BCA
ASSESSMENT REPORT

PROJECT:	46-52 Court Road Fairfield NSW 2165
STAGE:	Development Application Phase
REFERENCE:	25002.2-BCA
DATE:	5 February 2025
CLIENT:	Fairfield Investments No.1 Pty Ltd

Figure 6.16 – Basement 3 extended exit travel distances

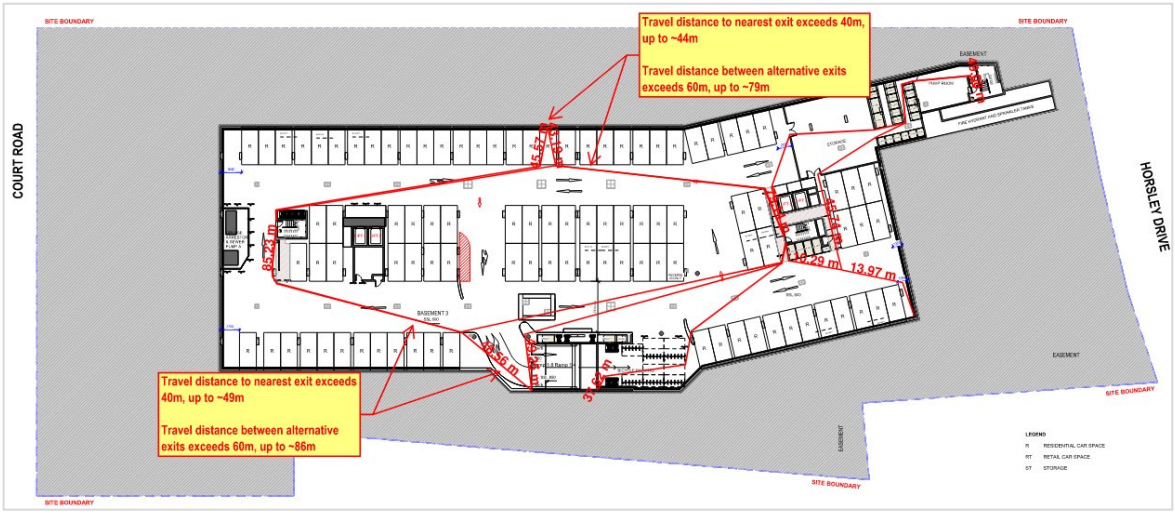
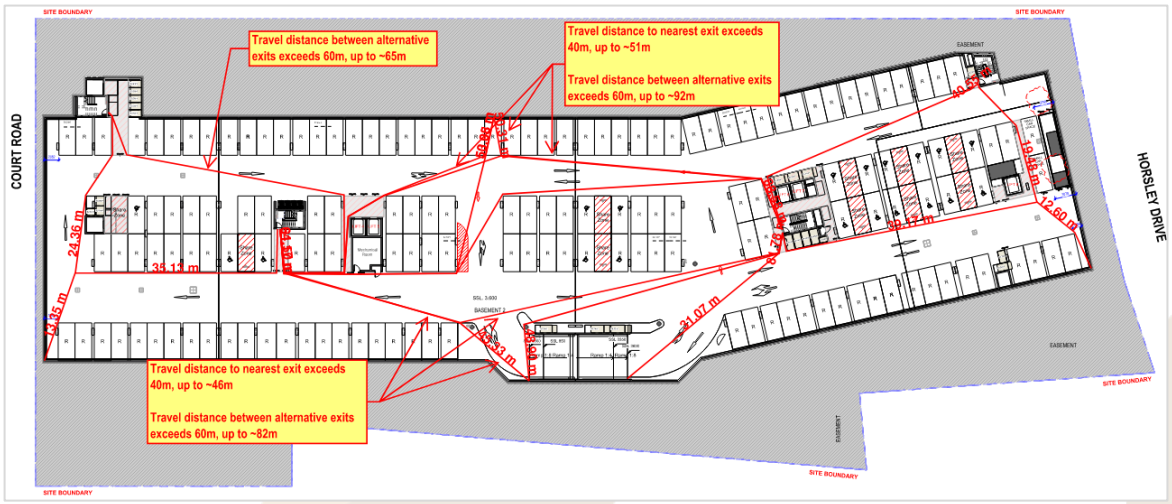
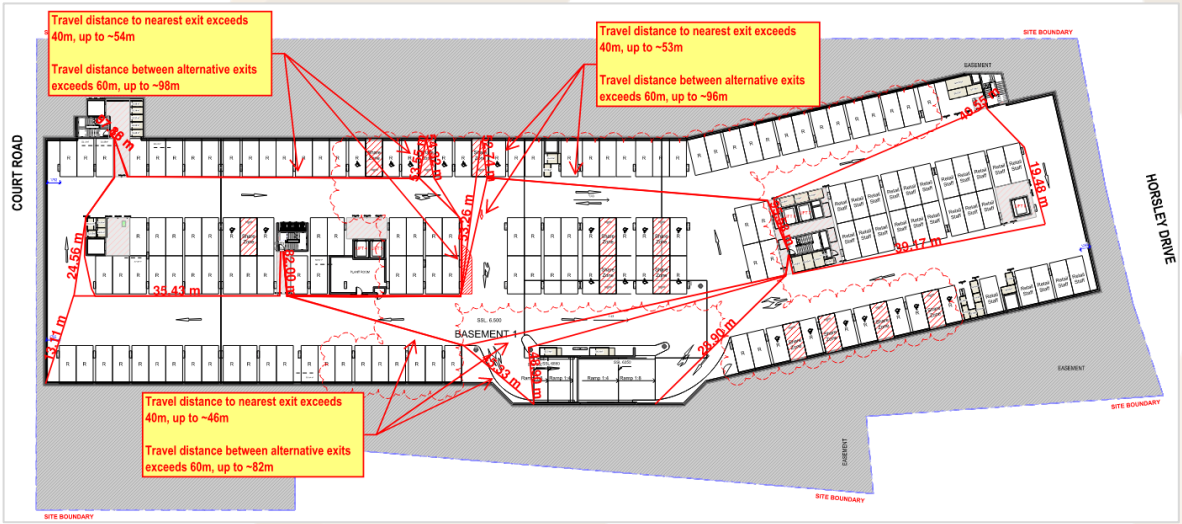
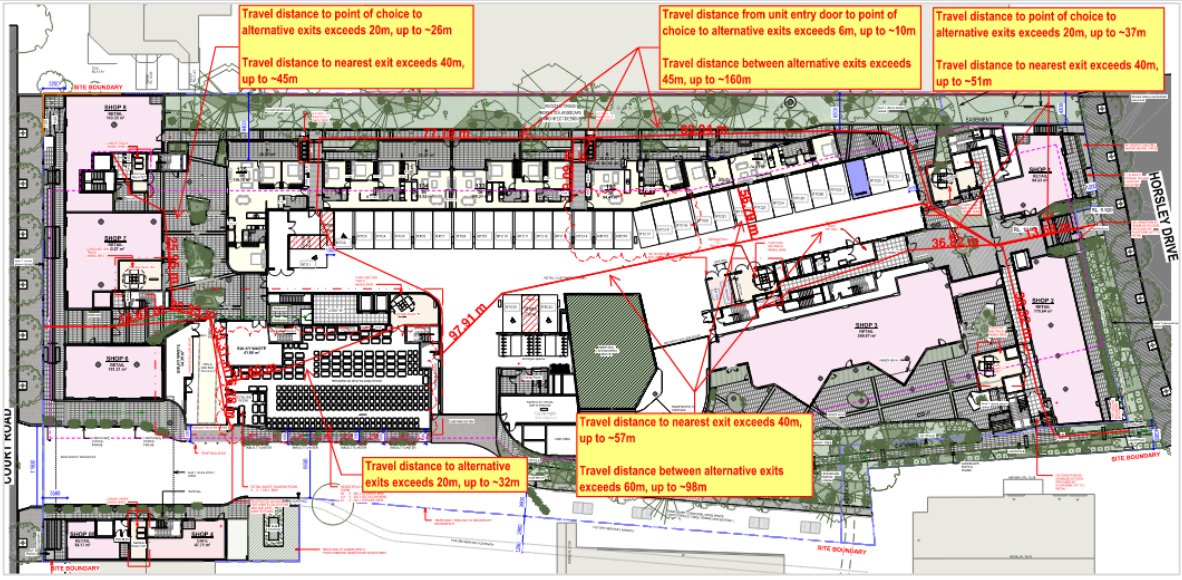
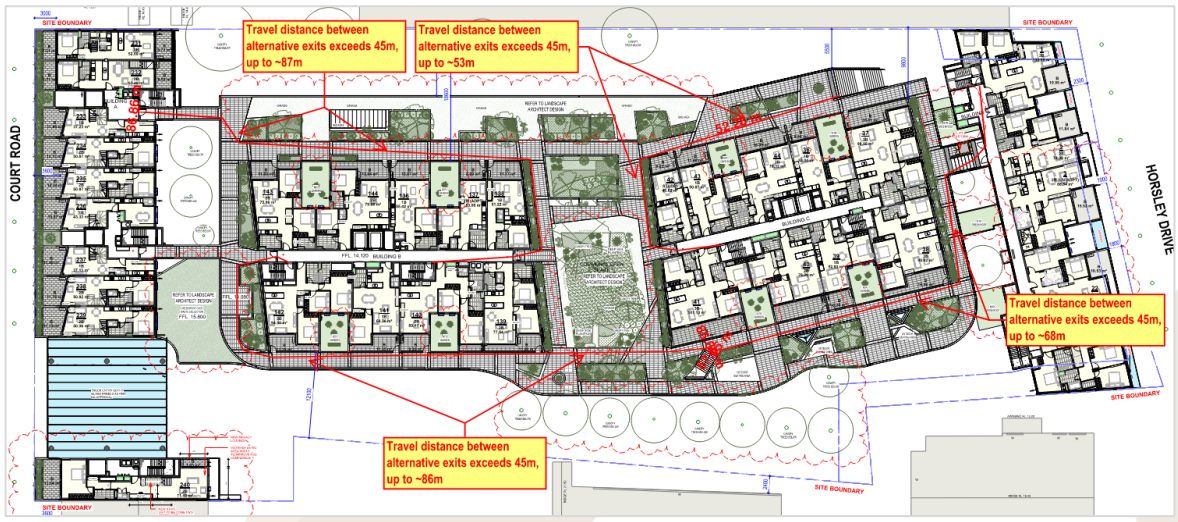
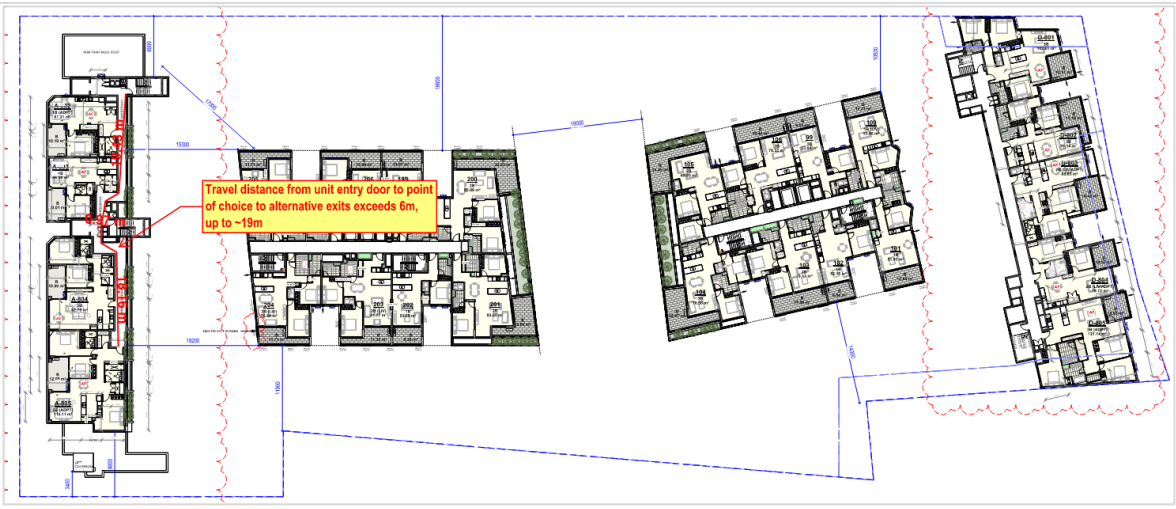
Part D2 – Provision for escape			
BCA Clause		**Comment/s**	**Status**
D2D5	Exit travel distances	Extended exit travel distances are identified as occurring throughout the building, as follows – (a) *Basement 3* (i) The travel distance to the nearest exit exceeds 40m, being up to ~49m. (b) *Basement 2* (i) The travel distance to the nearest exit exceeds 40m, being up to ~51m. (c) *Basement 1* (i) The travel distance to the nearest exit exceeds 40m, being up to ~54m. (d) *Ground floor* (i) The travel distance to a point of choice to alternative exits exceeds 20m, being up to ~37m; (ii) The travel distance from the entrance doorway of a SOU to a point of choice to alternative exits exceeds 6m, being up to ~10m; (iii) The travel distance to the nearest exit exceeds 40m, being up to ~57m. (e) *Level 2 – Level 7 (Building B)* (i) The travel distance from the entry doorway of a SOU to a point of choice to alternative exits exceeds 6m, being up to ~10m. (f) *Level 8 – Level 10 (Building D)* (i) The travel distance from the entry doorway of a SOU to a point of choice to alternative exits exceeds 6m, being up to ~19m.	DNC / PPS

Notwithstanding the above, the exit travel distances are to be provided in accordance with the following – *Class 2 parts* – (a) The entrance doorway of any sole occupancy unit must be not more than – (i) 6m from an exit or from a point which travel in different directions to 2 exits is available: or (ii) 20m from a single exit serving the storey at the level of egress to a road or open space. (b) No point on the floor which is not a sole occupancy unit must be more than 20m from an exit or from a point at which travel in different directions to 2 exits is available. *Class 6 parts* – (a) No point on a floor must be more than 20 m from an exit, or a point from which travel in different directions to 2 exits is available, in which case the maximum distance to one of those exits must not exceed 40 m. (b) The distance to a single exit serving a storey at the level of access to a road or open space may be increased to 30 m. *Class 7 parts* – (a) No point on a floor must be more than 20 m from an exit, or a point from which travel in different directions to 2 exits is available, in which case the maximum distance to one of those exits must not exceed 40 m.

Figure 6.23 – Discharge from fire isolated exits

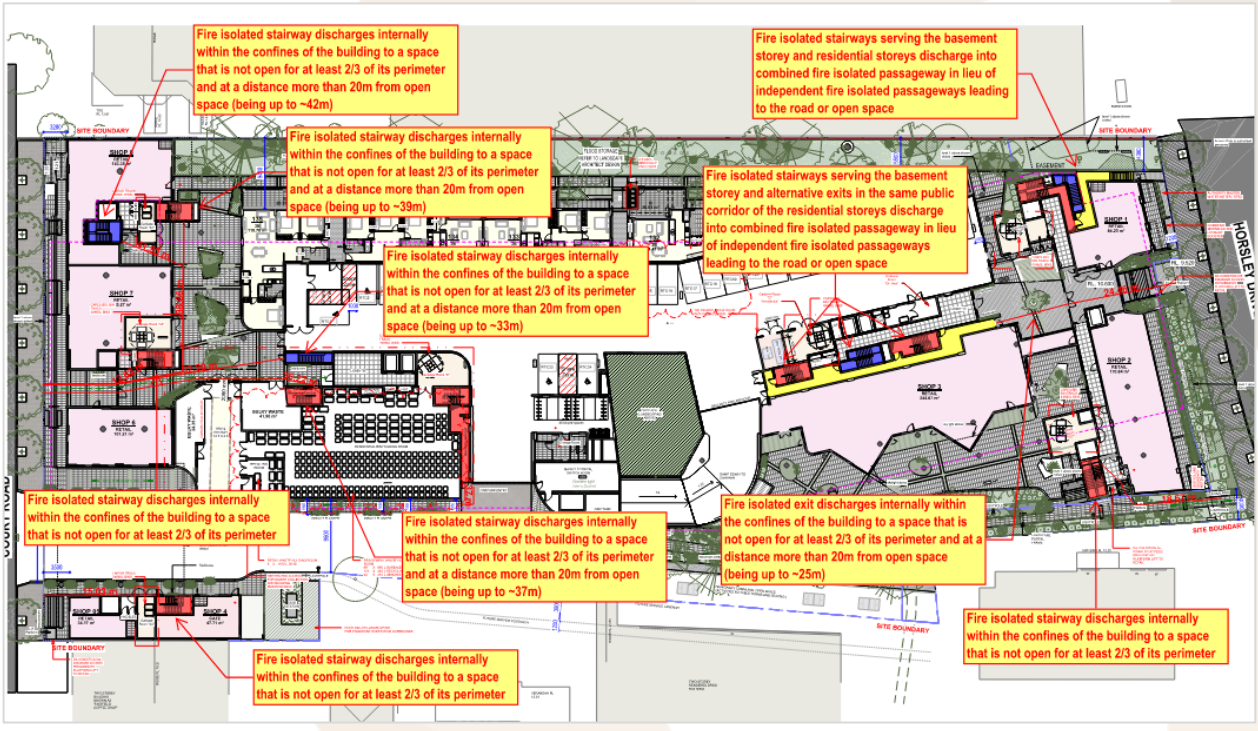
Part D2 – Provision for escape			
BCA Clause		**Comment/s**	**Status**
D2D11	Determination and measurement of exits and paths of travel to exits	(a) The required width of a stairway or ramp in a required exit or path of travel to an exit must— (i) be measured clear of all obstructions such as handrails, projecting parts of barriers and the like; and (ii) extend without interruption, except for ceiling cornices, to a height not less than 2 m vertically above a line along the nosings of the treads or the floor surface of the ramp or landing. (b) To determine the aggregate unobstructed width, the number of persons accommodated must be calculated according to D2D18.	Note
D2D12	Travel via fire-isolated exits	The following issue/s are identified in relation to the requirements of this clause – (a) The north-western fire isolated stairway serving the basement storeys discharges internally within the confines of the building (adjacent to Shop 8) at a point that is not open for at least 2/3 of its perimeter and at a distance more than 20m to open space, being up to ~42m. (b) The north-western fire isolated stairway serving the residential storeys at Building A discharges internally within the confines of the building at a point that is not open for at least 2/3 of its perimeter and at a distance more than 20m to open space, being up to ~39m. (c) The western fire isolated stairway serving the residential storeys at Building A discharges internally within the confines of the building (adjacent to Shop 7) at a point that is not open for at least 2/3 of its perimeter. (d) The western fire isolated stairway serving the basement storeys discharges internally within the confines of the building (adjacent to Bulky Waste room) at a point that is not open for at least 2/3 of its perimeter and at a distance more than 20m to open space, being up to ~33m. (e) The western fire isolated stairway serving the residential storeys at Building B discharges internally within the confines of the building (adjacent to the Bulky Waste room) at a point that is not open for at least 2/3 of its perimeter and at a distance more than 20m to open space, being up to ~37m. (f) The south-western fire isolated stairway serving the residential storeys at Building A discharges internally within the confines of the building (adjacent to Shop 4) at a point that is not open for at least 2/3 of its perimeter. (g) The south-eastern fire isolated stairway serving the residential storeys at Building D discharges internally within the confines of the building (adjacent to Shop 2) at a point that is not open for at least 2/3 of its perimeter.	DNC / PPS

(2) Each fire-isolated stairway or fire-isolated ramp must provide independent egress from each storey served and discharge directly, or by way of its own fire-isolated passageway –
  (a) to a road or open space; or
  (b) to a point—
    (i) in a storey or space, within the confines of the building, that is used only for pedestrian movement, car parking or the like and is open for at least ⅔ of its perimeter; and
    (ii) from which an unimpeded path of travel, not further than 20 m, is available to a road or open space; or

Figure 6.24 – Distance to open space from northern non-fire isolated stairway

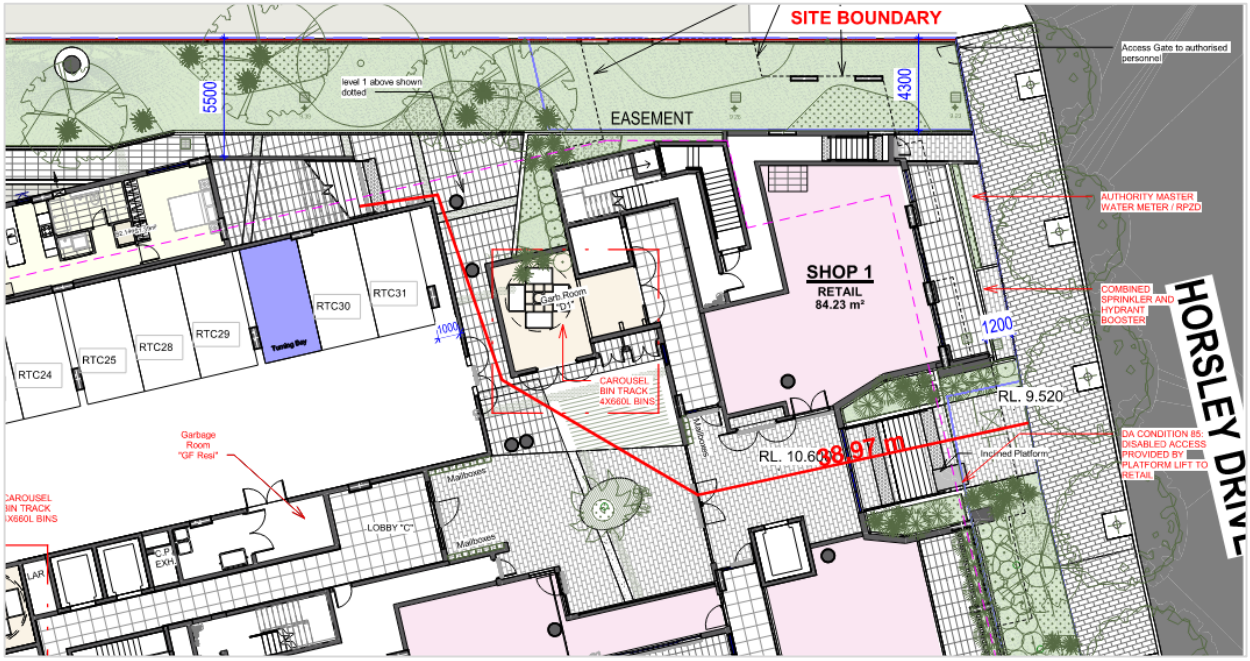
Part D2 – Provision for escape			
BCA Clause		**Comment/s**	**Status**
D2D13	External stairways or ramps in lieu of fire isolated exits	Not applicable.	N/A
D2D14	Travel by non-fire-isolated stairways or ramps	The distance from the point of discharge from the northern non-fire-isolated stairway to open space is identified as exceeding 30m, being up to ~39m. Notwithstanding the above, the following must be complied with - (1) A non-fire-isolated stairway or non-fire-isolated ramp serving as a required exit must provide a continuous means of travel by its own flights and landings from every storey served to the level at which egress to a road or open space is provided. (2) In the Class 2 parts, the distance between the doorway of a room or sole-occupancy unit and the point of egress to a road or open space by way of a stairway that is not fire-isolated and is required to serve that room or sole-occupancy unit must not exceed 60 m. (3) In the Class 2 parts, a required non-fire-isolated stairway must discharge at a point not more than— (a) 15 m from a doorway providing egress to a road or open space or from a fire-isolated passageway leading to a road or open space; or (b) 30m from one of 2 such doorways or passageways if travel to each of them from the non-fire-isolated stairway or non-fire-isolated ramp is in opposite or approximately opposite directions. (4) In the Class 2 parts, if 2 or more exits are required and are provided by means of internal non-fire-isolated stairways or non-fire-isolated ramps each exit must— (a) provide separate egress to a road or open space; and (b) be suitably smoke-separated from each other at the level of discharge.	DNC / PPS

Figure 6.25 – Paths of travel to road

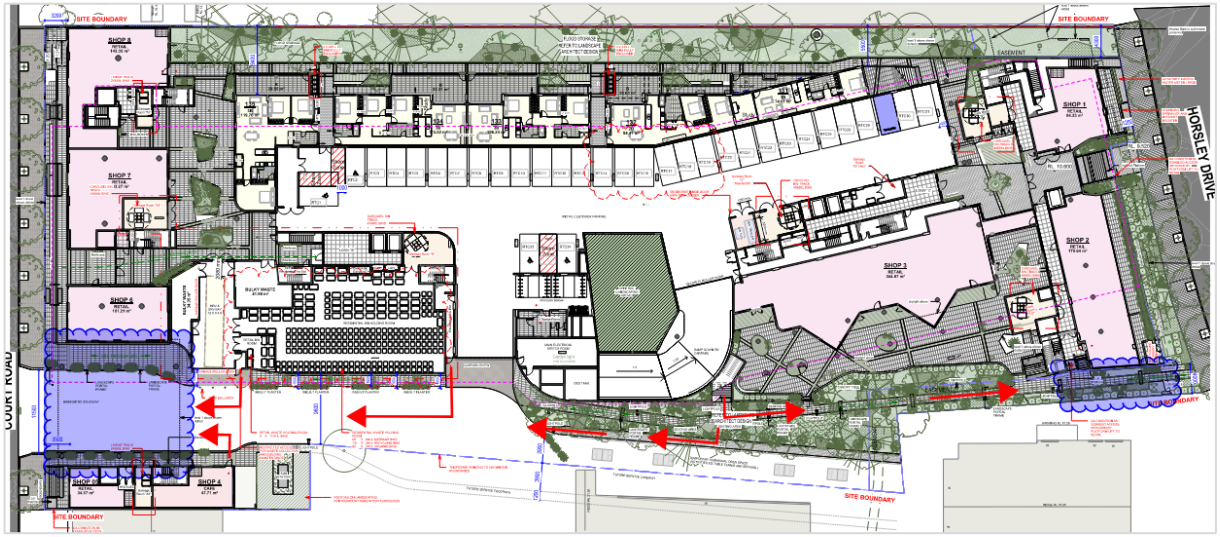
Part D2 – Provision for escape			
BCA Clause		**Comment/s**	**Status**
D2D15	Discharge from exits	The paths of travel from southern exits at the ground floor are identified as discharging to open space and then requiring occupants to pass back under the building to reach the road. Notwithstanding the above, the following must be complied with - (1) An exit must not be blocked at the point of discharge and where necessary, suitable barriers must be provided to prevent vehicles from blocking the exit, or access to it. (2) If a required exit leads to an open space, the path of travel to the road must have an unobstructed width throughout of not less than— (a) the minimum width of the required exit; or (b) 1 m, whichever is the greater. (3) If an exit discharges to open space that is at a different level than the public road to which it is connected, the path of travel to the road must be by – (a) a ramp or other incline having a gradient not steeper than 1:8 at any part, or not steeper than 1:14 if required by the Deemed-to-Satisfy Provisions of Part D4; or (b) a stairway complying with the Deemed-to-Satisfy Provisions of the BCA. (4) The discharge point of alternative exits must be located as far apart as practical.	DNC / PPS

Figure 6.26 – Eastern fire isolated stairways

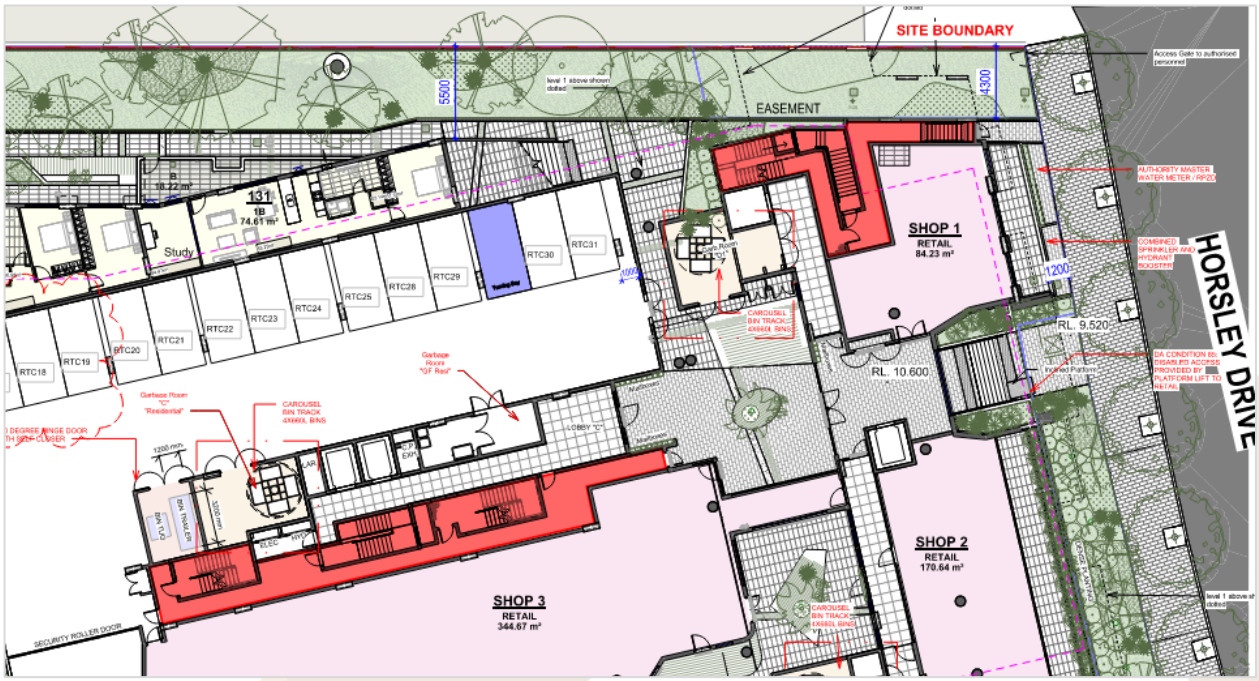
Part D3 – Construction of exits			
BCA Clause		**Comment/s**	**Status**
D3D5	Separation of rising and descending stair flights	In the fire isolated stairways highlighted in the figure below — (a) there must be no direct connection between— (i) a flight rising from a storey below the lowest level of access to a road or open space; and (ii) a flight descending from a storey above that level; and (b) any construction that separates or is common to the rising and descending flights must be— (i) non-combustible; and (ii) smoke proof in accordance with S11C2.	CRA

Figure 6.27 – Swing door to eastern fire isolated exit

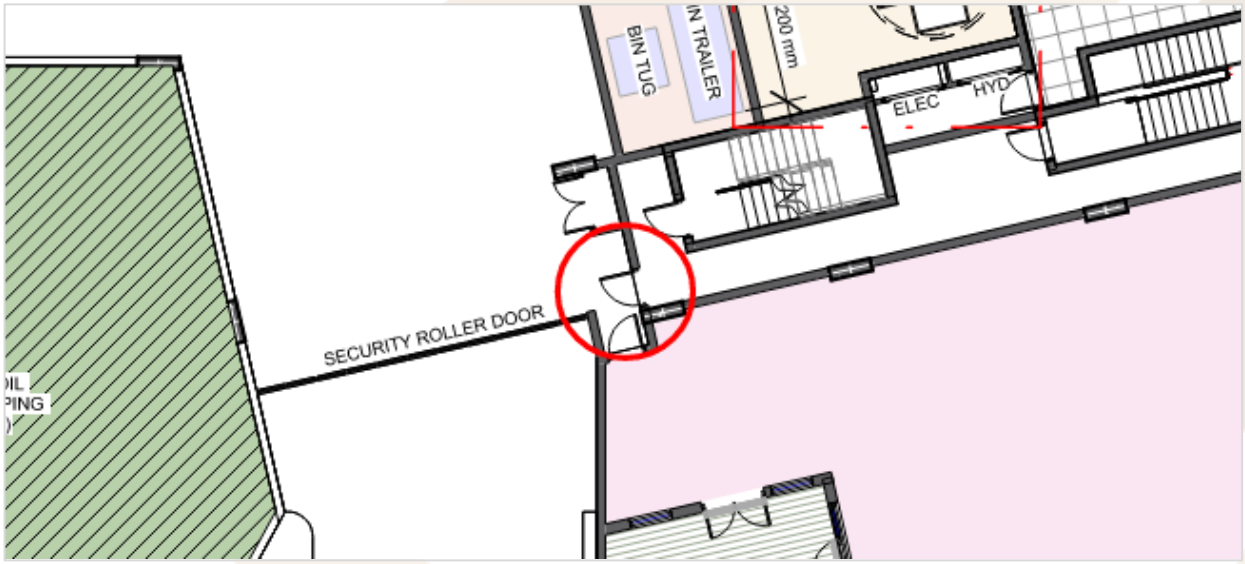
Part D3 – Construction of exits			
BCA Clause		**Comment/s**	**Status**
D3D25	Swinging doors	Referring to the figure below, the swing door to the eastern fire isolated passageway, accessed via the ground floor carpark area is identified as swinging against the direction of egress. Notwithstanding the above, swinging doors in a required exit or forming part of a required exit must be provided in accordance with the following - (a) must not encroach— (i) at any part of its swing by more than 500 mm on the required width (including any landings) of a required stairway, ramp or passageway if it is likely to impede the path of travel of the people already using the exit. (ii) when fully open, by more than 100 mm on the required width of the required exit; and (b) must swing in the direction of egress unless - (i) it serves a building or part with a floor area not more than 200 m^2, it is the only required exit from the building or part and it is fitted with a device for holding it in the open position; or (ii) it serves a sanitary compartment or airlock (in which case it may swing in either direction); and (c) must not otherwise impede the path or direction of egress.	DNC
